Liverpool Civic Place

Supplementary Design Report

fjmt studio architecture interiors urban landscape community
May 4 – Master Plan – Rev 0

fjmt prepared the Architectural Master Plan Design Statement which formed part of the 2019 formal lodgement. This supplementary report is intended to be read in conjunction with that original design statement, and provides a response to items raised by the approval consent authority. Numerous items are covered as follows:

Deposited Plan for Augusta Cullen Plaza (Lot 201- Council owned) and 300 Macquarie Street (Lot 200): Below Ground

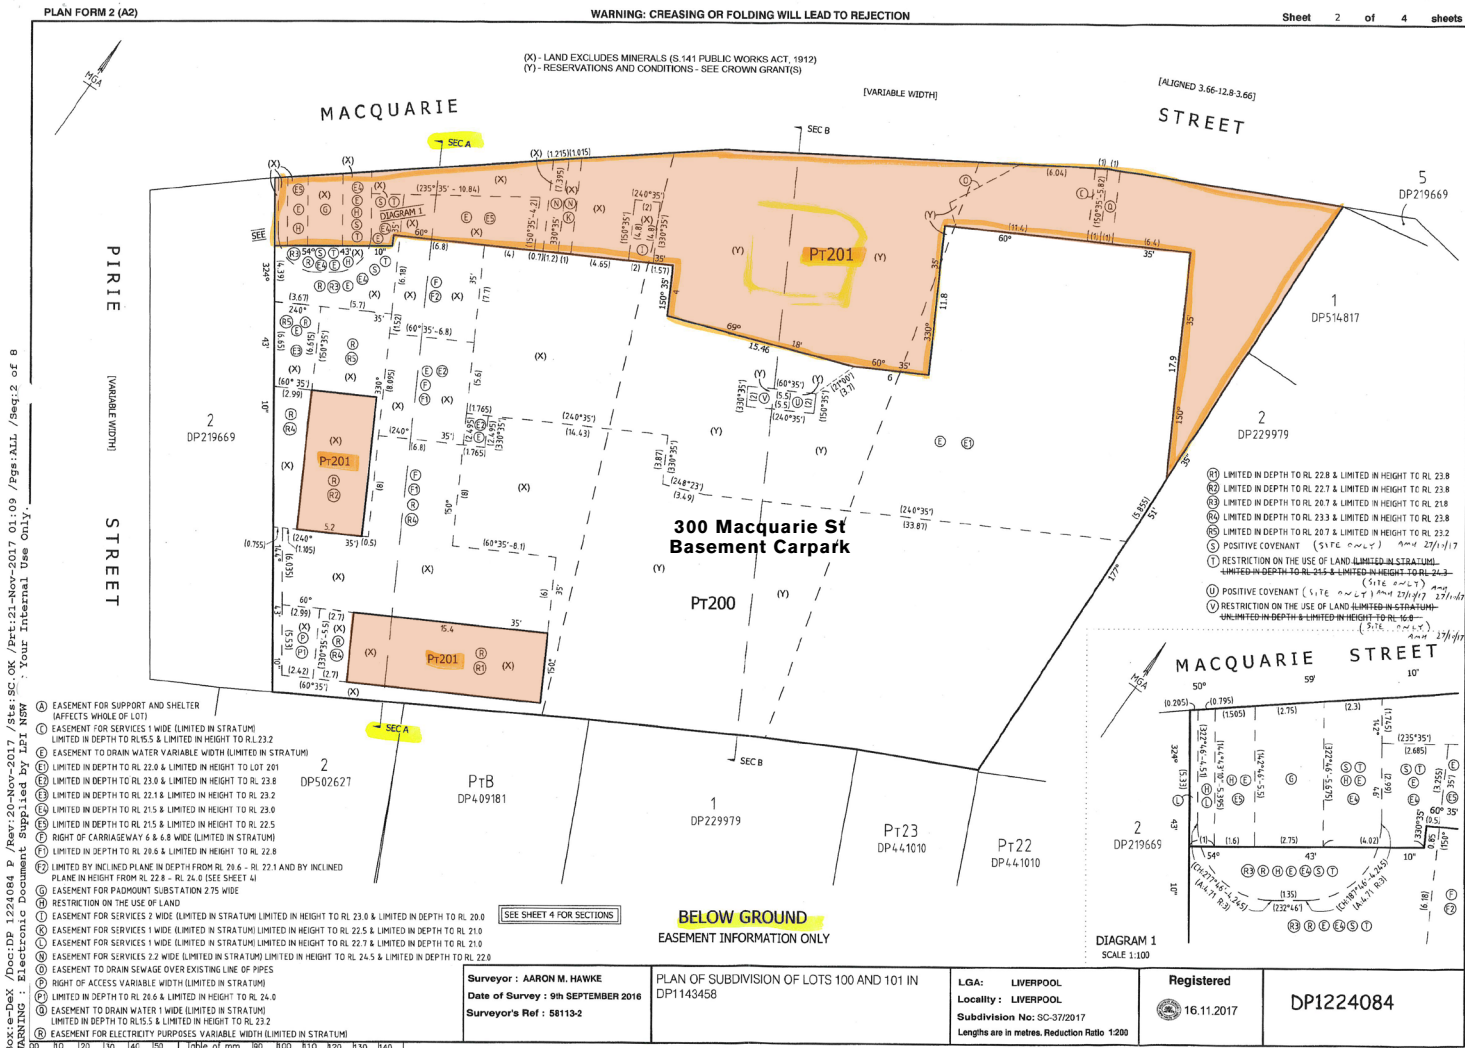
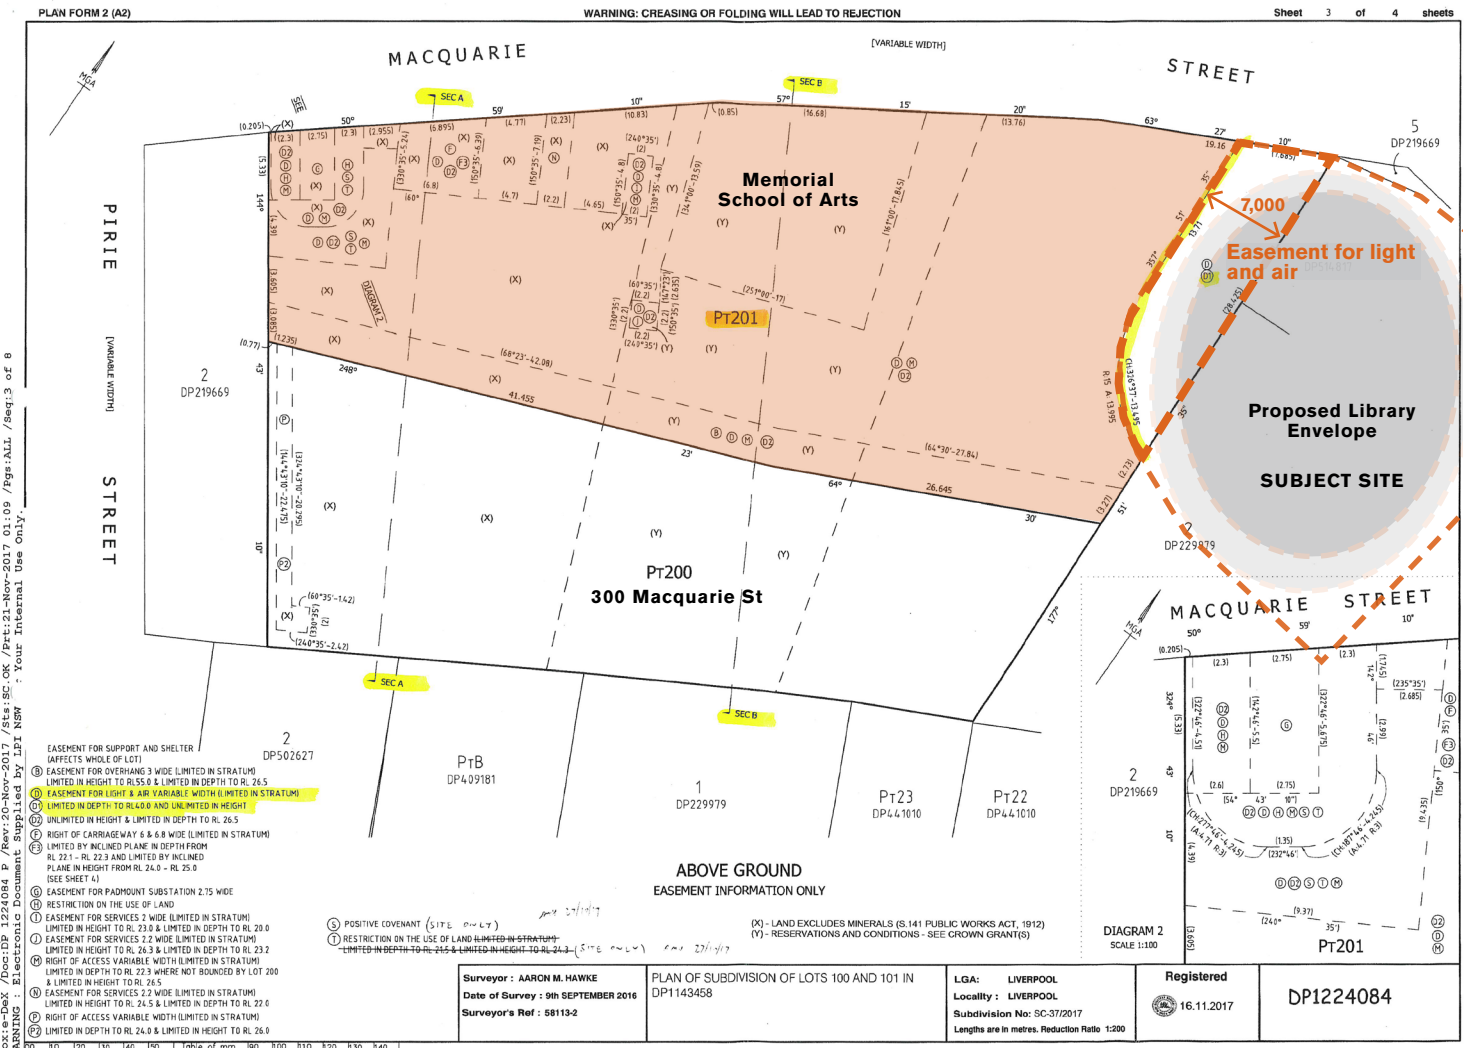
This chapter responds to RFI Arch 1J (Access Easements - 306-210 Macquarie Street) and part of Arch 3E (Landscape) as outlined in the Supplementary Design Report by Ethos Urban.

The proposed library envelope projects 7m west in to an easement within Augusta Cullen Plaza to maximise on site public domain dimensions, and position the public library at the terminus of Macquarie Street.

The deposited plans below show easement information below ground and above, with the outline of the proposed library superimposed onto the easement. The land parcels owned by Liverpool City Council are highlighted in orange (Lot 201), while Lot 200 on which 300 Macquarie Street is built is under private ownership. The subject site has easement rights onto Lot 201 (council owned) that were granted in 2016 based on the 2016 Masterplan Envelopes (refer to chapter 7 Building Separation).

Scott Street due-east. Image represents both the proposed masterplan envelope (blue shade) and the library reference scheme design therein. The statue is highlighted orange.

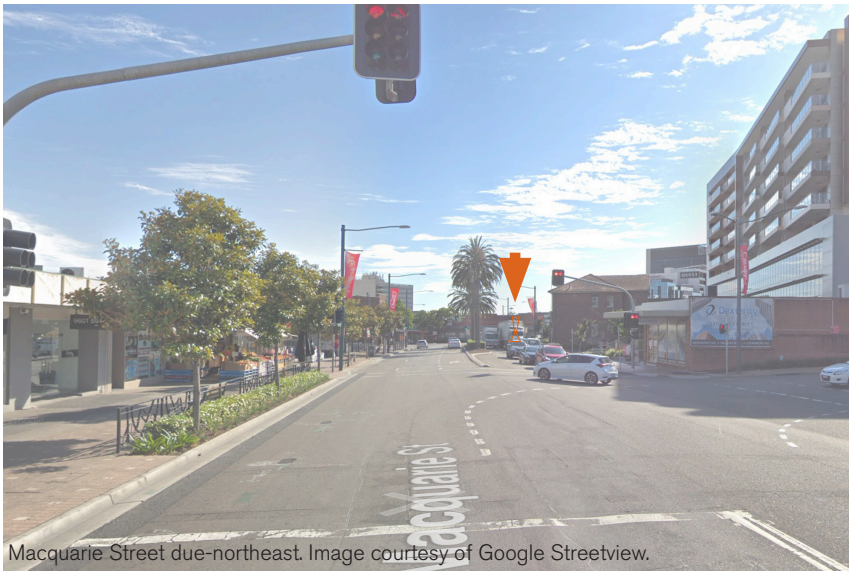
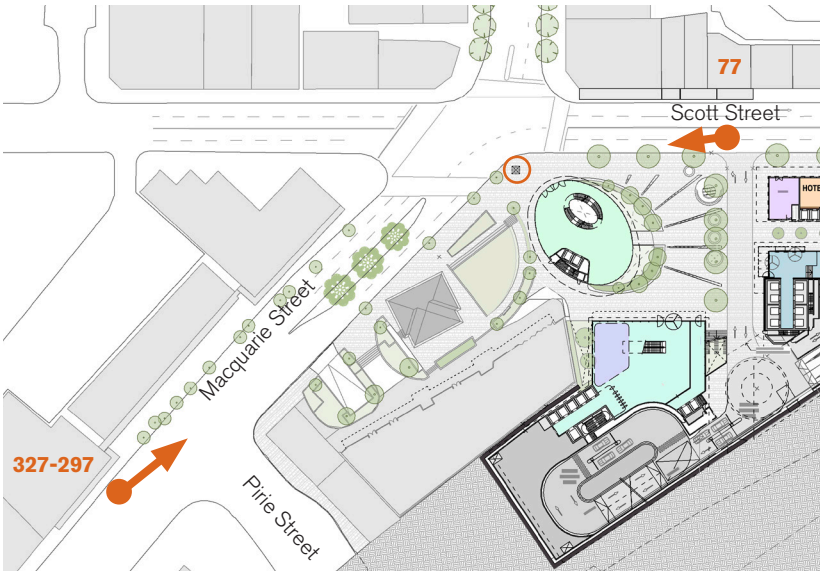
FJMT to provide perspectives. Perspectives looking from around 77 Scott Street and 327-297 Macquarie Street towards the heritage item are required for further assessment

The perspectives provided illustrate both the master plan envelopes (blue) and the reference scheme design within. The statue is highlighted in orange to assist legibility. Both CGI views are also zoomed in to magnify the relationship between the statue and the proposal. The camera angles and positions in plan are otherwise faithful.

- The reference design steps inwards toward the ground floor creating a larger buffer, improving separation and views to the statue.
- Line of site and view access toward the statue along Scott Street will significantly increase with the demolition of the Crunch Fitness building line, replaced with the open northern segment of the Civic Square (as highlighted orange in the plan diagram on the preceding page 46)..

- Similarly in this view, the reference design facade line stepping in toward ground floor increases buffer space around the statue, bringing it and the Memorial School of Arts into primary focus.

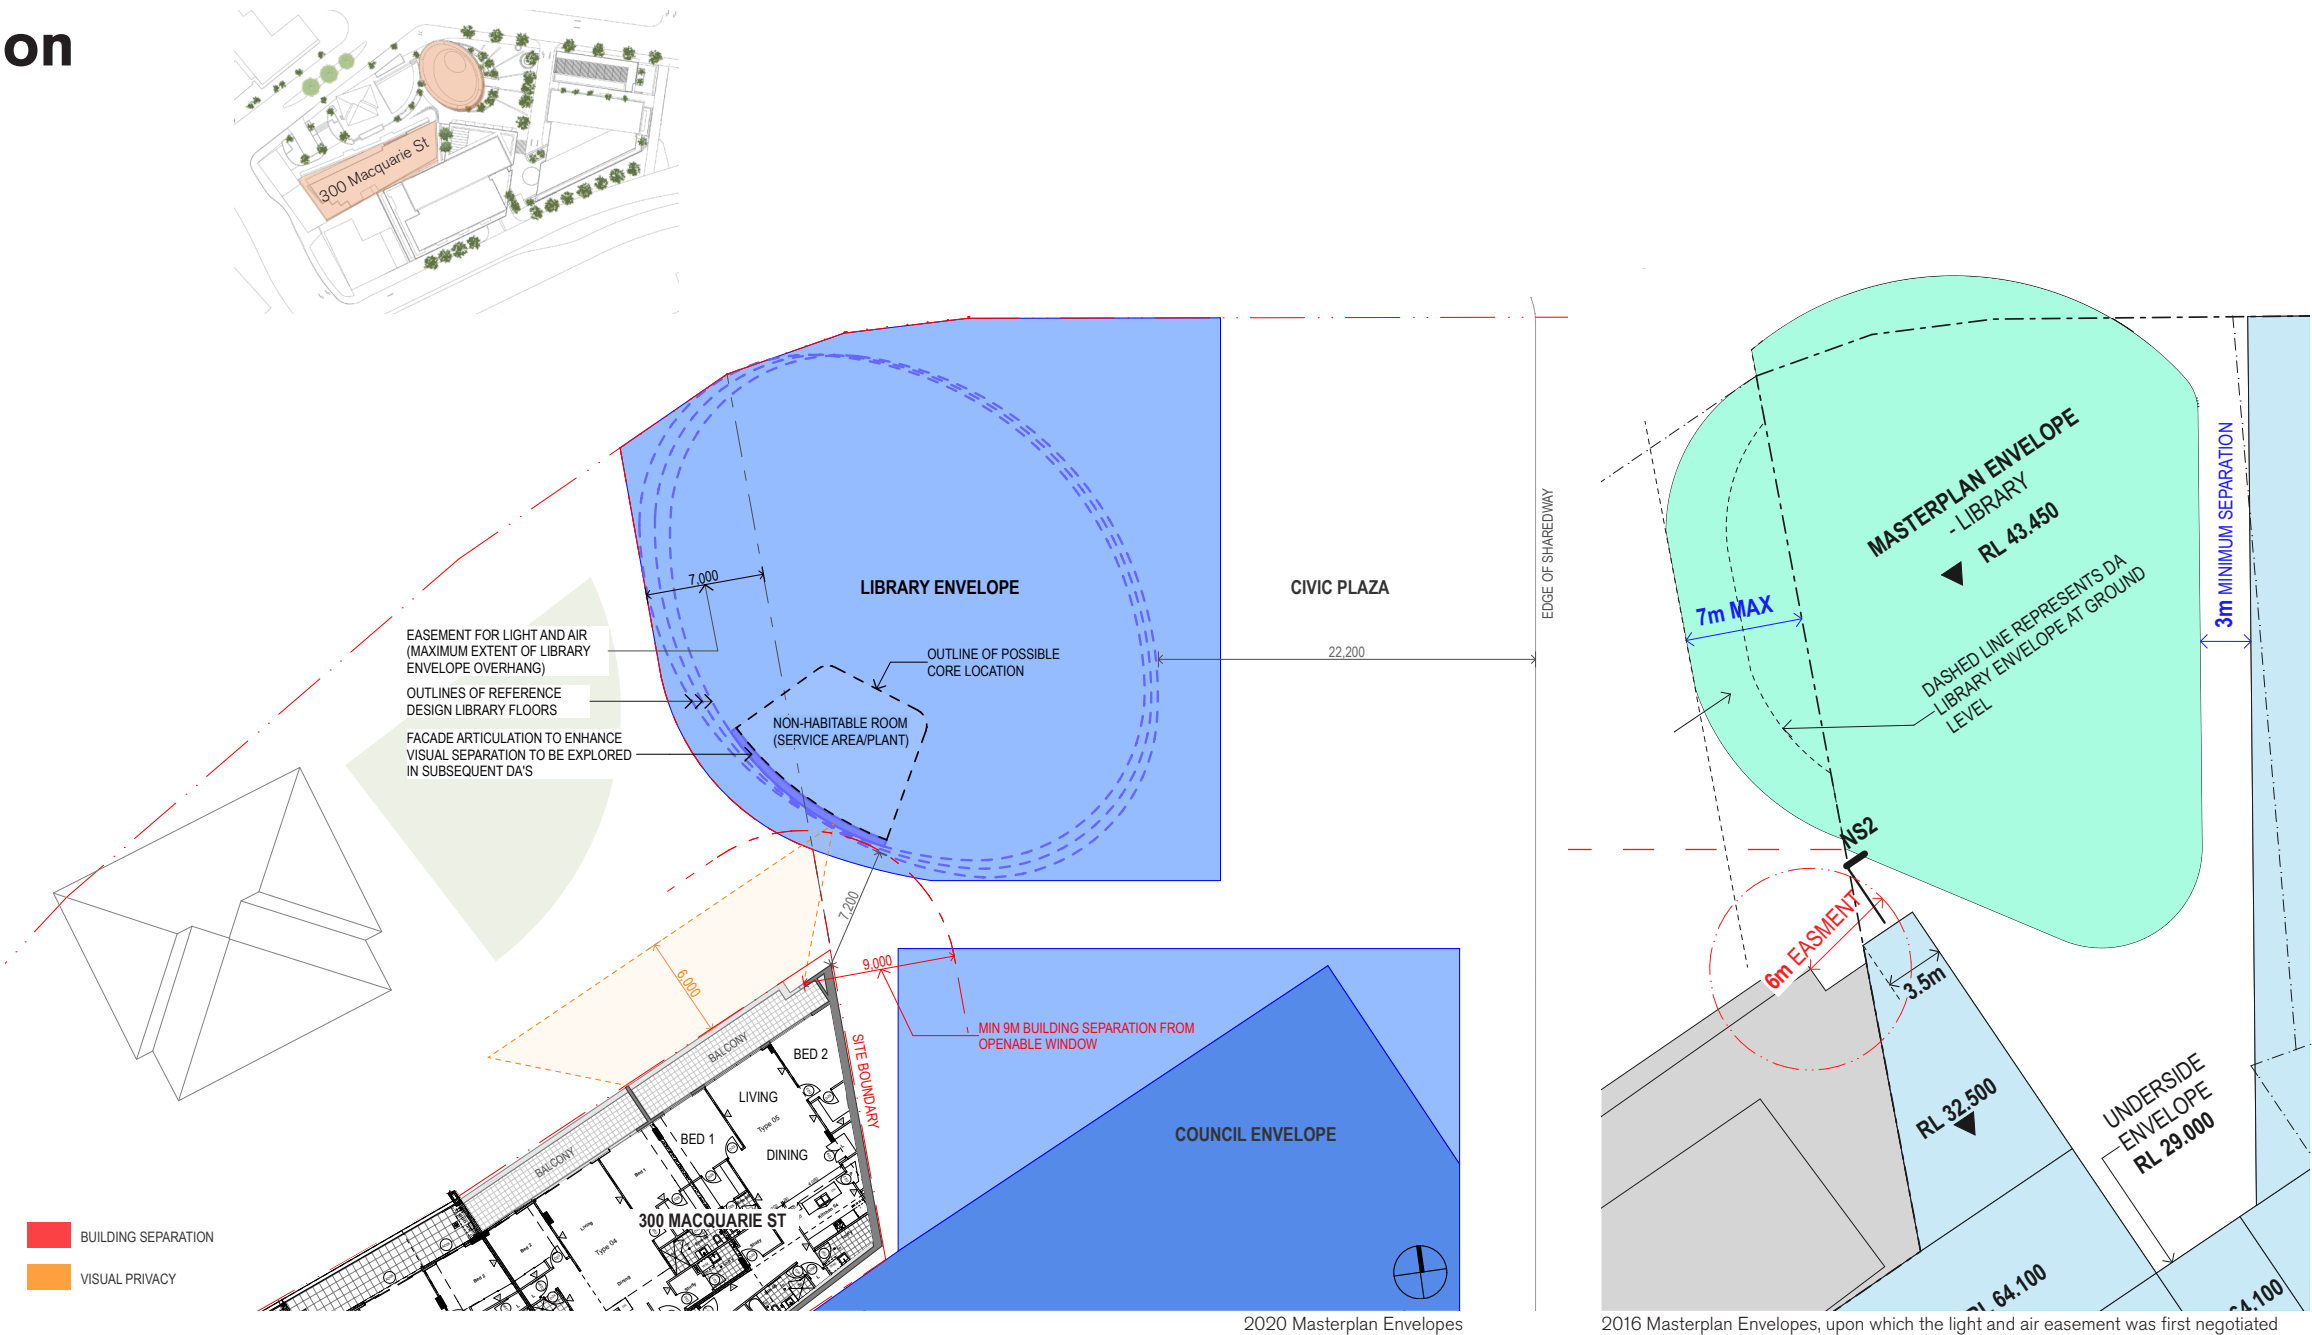
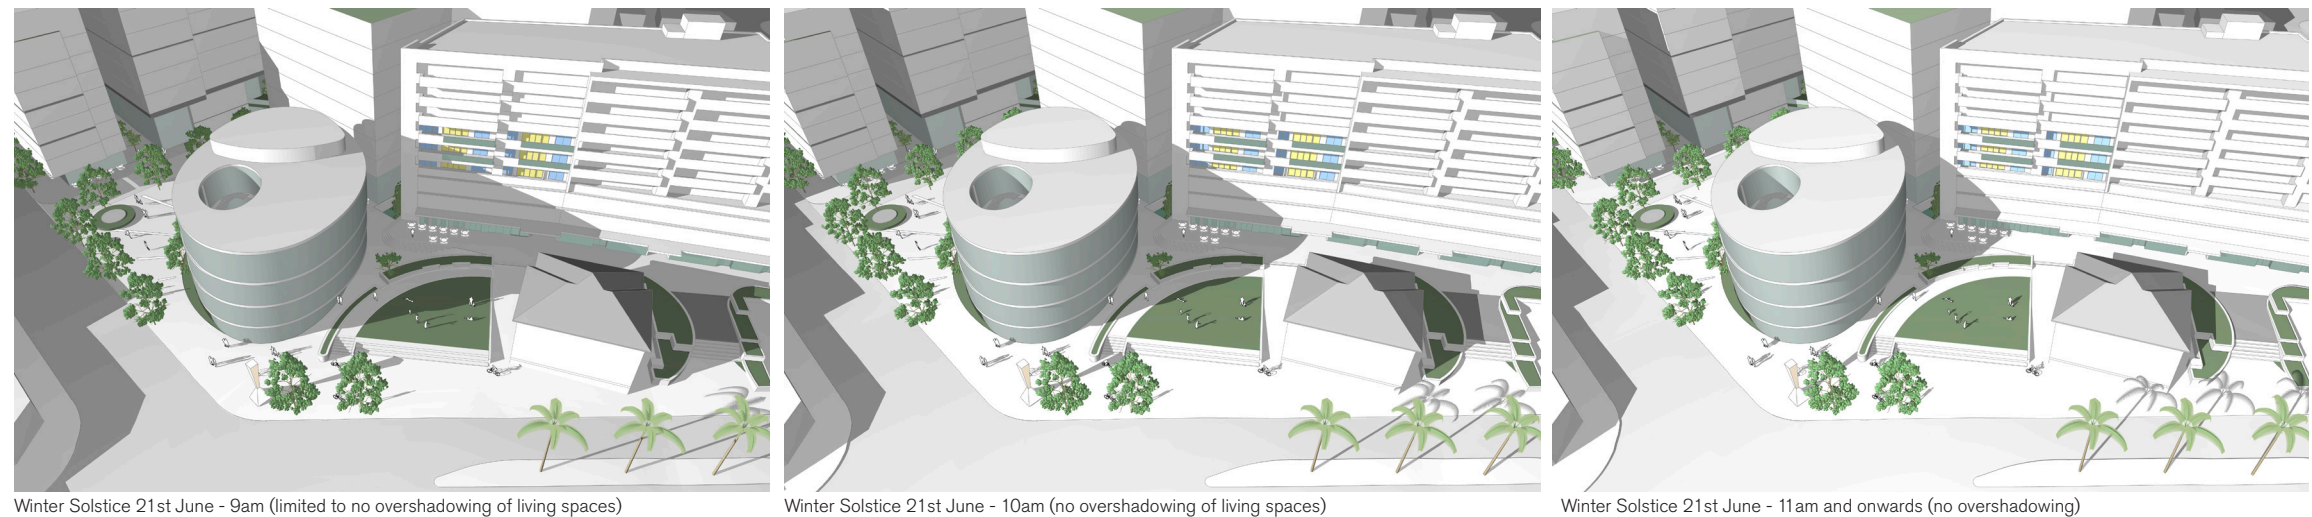
This chapter responds to RFI Arch 1G (Residential amenity of 300 Macquarie Street) as outlined in the Supplementary Design Report by Ethos Urban.

The proposed library envelope extends 7m west into a Easement. This positions the library atop Macquarie Street to ensure maximum visibility from the city's important axis. Architectus has requested that we provide further information on the proposed separation between the library envelope and 300 Macquarie Street.

The diagrams adjacent study the potential worst-case overshadowing, 21st June, and show that living spaces in affected apartments are only impacted for a short duration in the morning. There is no overshadowing of living spaces after 10am.

While the Library's location will inevitably result in shadows cast over the existing development, this overshadowing is limited to early morning and all apartments will still achieve compliant solar access, well over the minimum 2 hours.

Important to note also, that ground level retail receives full sun light from 11am onwards and throughout the lunchtime period.
